R05KA

**SUBJECT: RECALL R05KA LOOSE WIRING CONNECTIONS AT BATTERY
DISCONNECT SWITCH**

Battery Switch Connections

MODELS AFFECTED: Vision, All American, TC2000

Vision

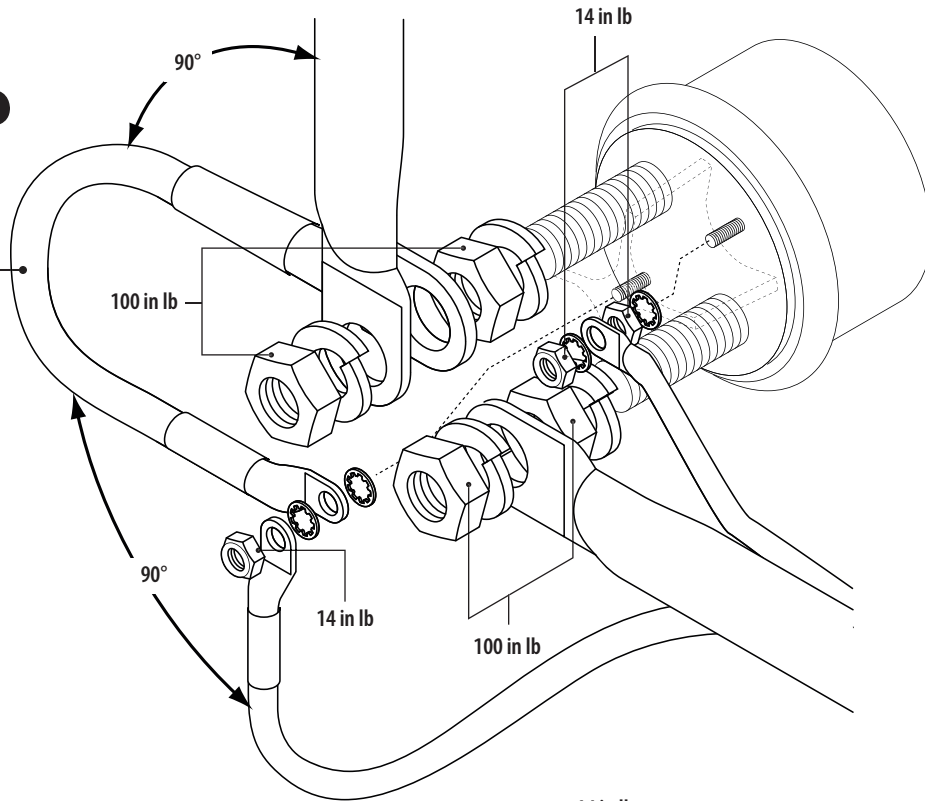
On Blue Bird Vision installations, a jumper cable (0074324) is attached between the two (one large and one small) positive-side terminals. This jumper is not required on All American or TC2000 models. On Vision, reinstall the connection on the positive-side 10-32 stud which has two cables with components in this stacking order:

If the jumper cable is absent on a Blue Bird Vision, install one as shown in the illustration on page 2.

Install Positive Side Jumper Cable on Blue Bird Vision if one is not present.

1. Star Washer
2. Cable
3. Star Washer
4. Cable (Turn cable connector barrel ~90 degrees from first cable.)
5. Nylock Nut (0043743). Torque to 14 in. lbs.

All American & TC2000

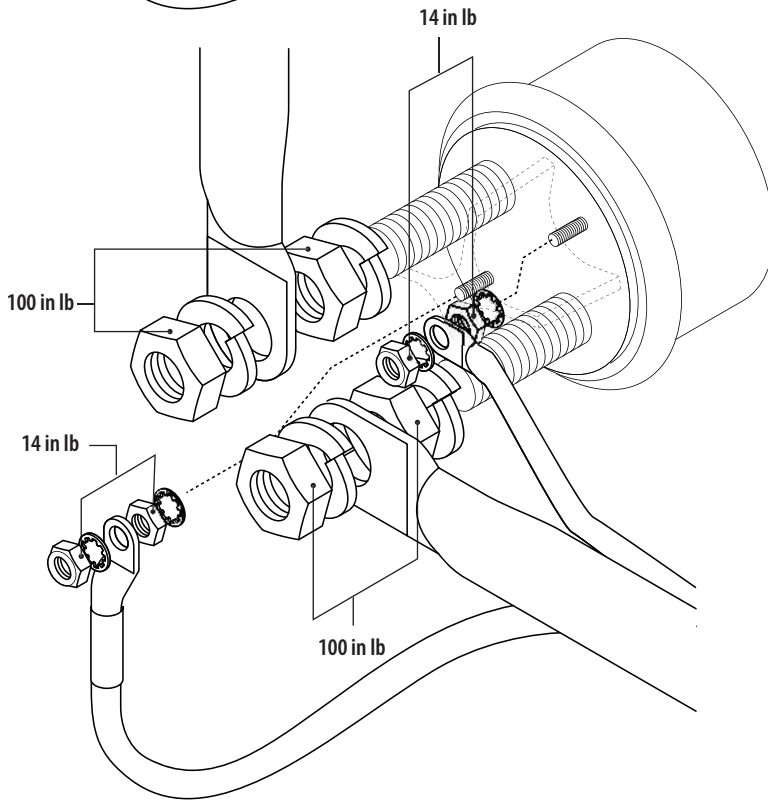
On the other 10-32 stud on Vision, and on both 10-32 studs on All-American and TC2000, reinstall the connection(s) with components in this stacking order:

1. Star Washer
2. Hex Nut. Torque to 14 in. lbs.
3. Cable
4. Star Washer
5. Nylock Nut (0043743). Torque to 14 in. lbs.
